CHICK-FIL-A JSP 18-75

Public hearing at the request of GPD group for JSP 18-75 Chick-Fil-A for Planning Commission's recommendation to the City Council for approval of rezoning from Regional Center (RC) to Regional Center with a Planned Development 2 options (PD-2), Preliminary Site Plan with a PD-2, Special Land Use and Stormwater Management Plan approval. The subject property is located at the southeast corner of Novi Road and Twelve Oaks Mall Road in Section 14. The applicant is proposing to develop a 4,990 square foot Chick-Fil-A restaurant with a drive-through. The applicant will be utilizing the Planned Development 2 (PD-2) option to propose a drive-thru.

PLANNING REVIEW: REZONING

PLANNING REVIEW: SITE PLAN

This Circulation Plan is based on the first possible exits to Twelve Mile Road and Novi Road.

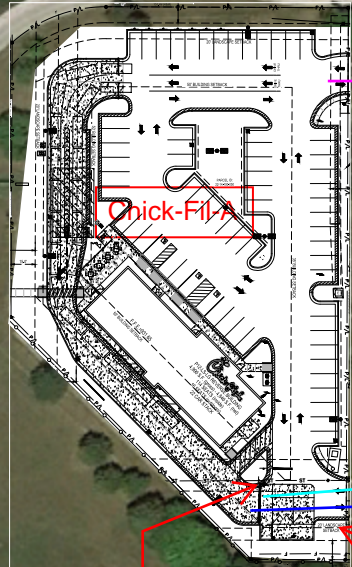
2. The applicant shall direct exiting traffic from the site to the eastern exit to Twelve Oaks Mall road with appropriate site signage, subject to review and approval by City's Traffic Consultant at the time of final site plan submittal;
